Table 2: Responses to Public Review Comments

- Attachments:**
Attachment A: Geotechnical Analysis for Sio Silica Extraction Project - Public Version
Attachment B: Updated EAP Figure 1-1 to show GWWD Shoal Lake Aqueduct
Attachment C: Preliminary Traffic Projections Memorandum

Updated EAP Figure 1-1 to show GWWD
Shoal Lake Aqueduct

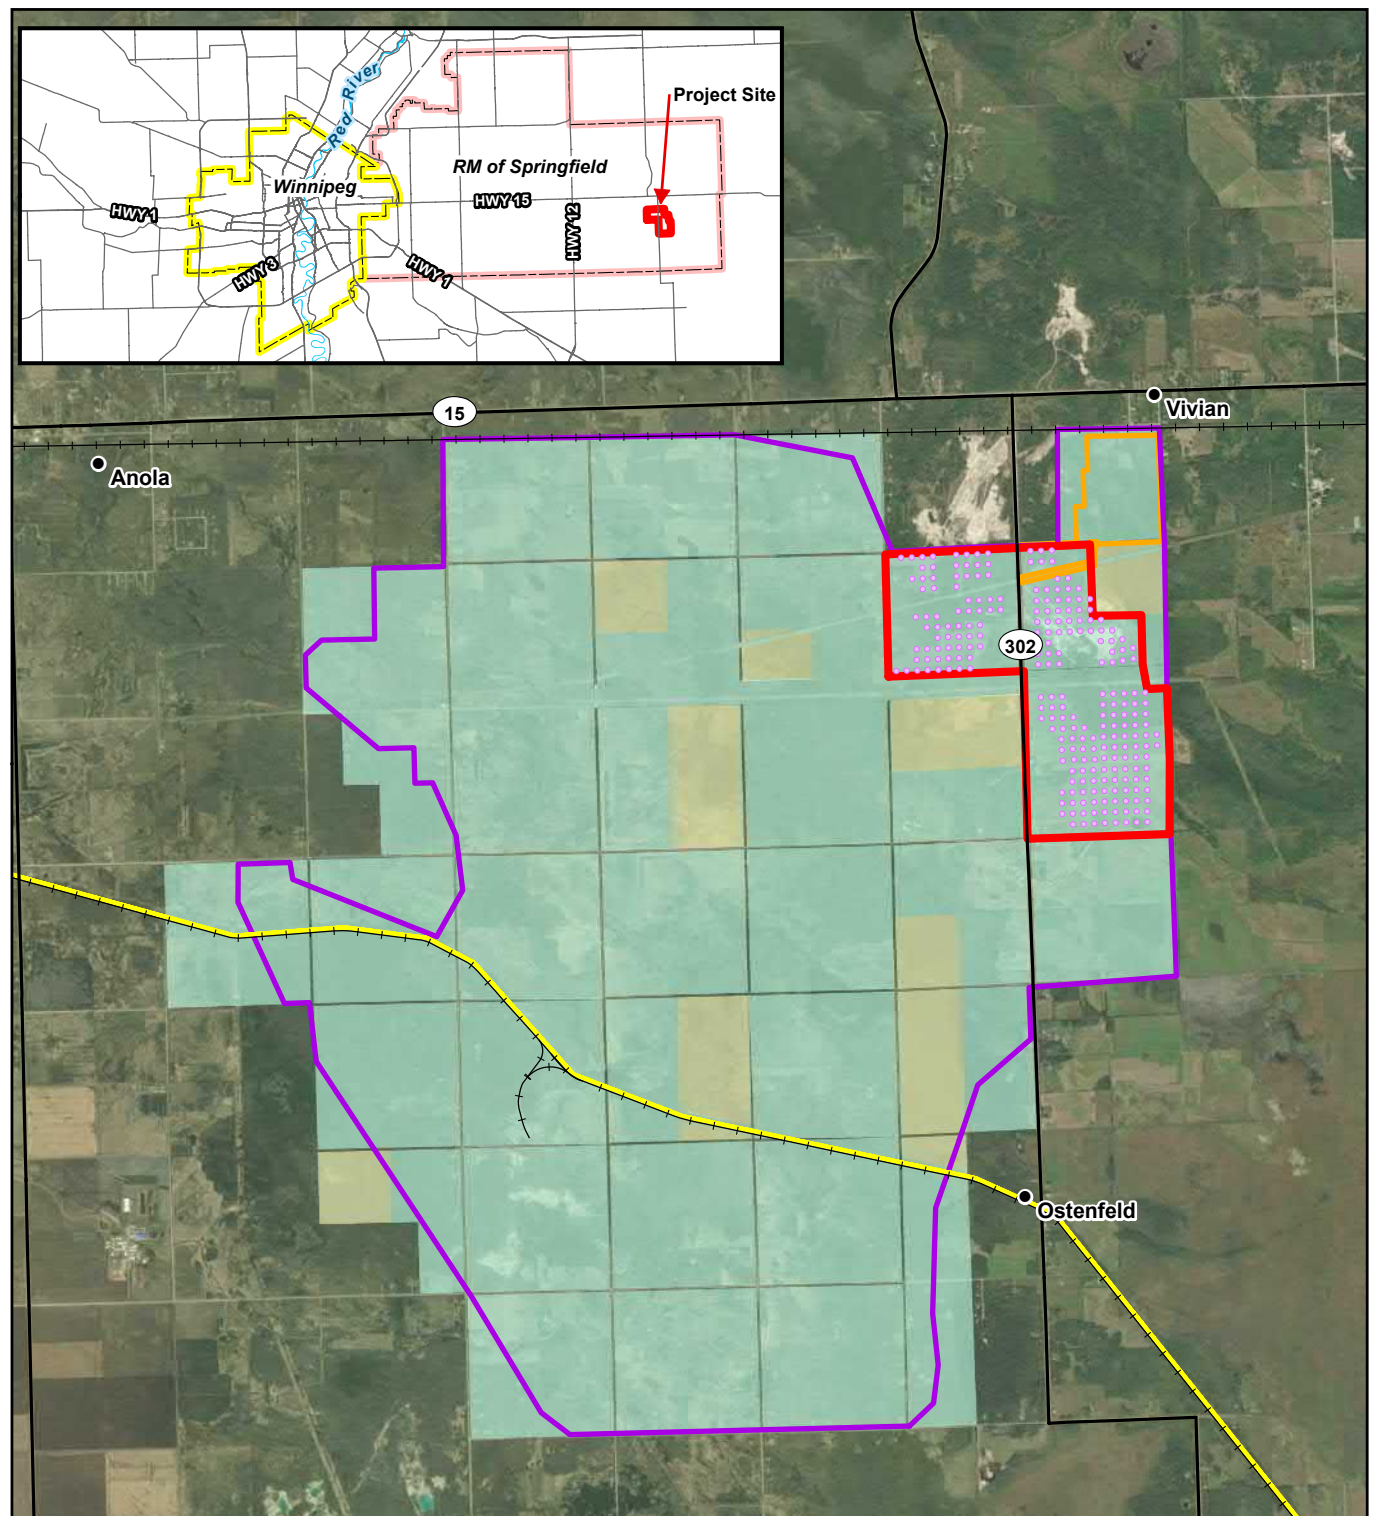
Email forwarded by Shandi Strong, originally written by Jon Gerrard (MLA), received Nov. 1, 2021, Public comments Batch #3	4	<i>"The size and the scope of the CanWhite Sands project means it is likely that there will be slurry lines crossing the line of Winnipeg's Aqueduct. It is a concern should there be subsidence under the Aqueduct, or a spill of toxic chemicals in proximity to the Aqueduct ."</i>	<p>As described in the EAP (Section 2.2, Silica Sand Extraction Process), the slurry line contains only water and sand and therefore poses no risk of contamination caused by a spill of toxic chemicals. Also see response #1 regarding subsidence.</p> <p>Please refer to Figure 1-2 in the EAP which provides the location of the proposed extraction wells for the first four to five years of operation, and revised Figure 1-1, which shows the location of the Greater Winnipeg Water District (GWWD) Shoal Lake Aqueduct in relation to the proposed Project Site (Attachment B). Note that none of the extraction sites proposed in this application approach or cross the aqueduct.</p> <p>Any future Notice of Alteration for operations that might fall within the proximity of the aqueduct will consider potential environmental effects on the aqueduct.</p>	N/A
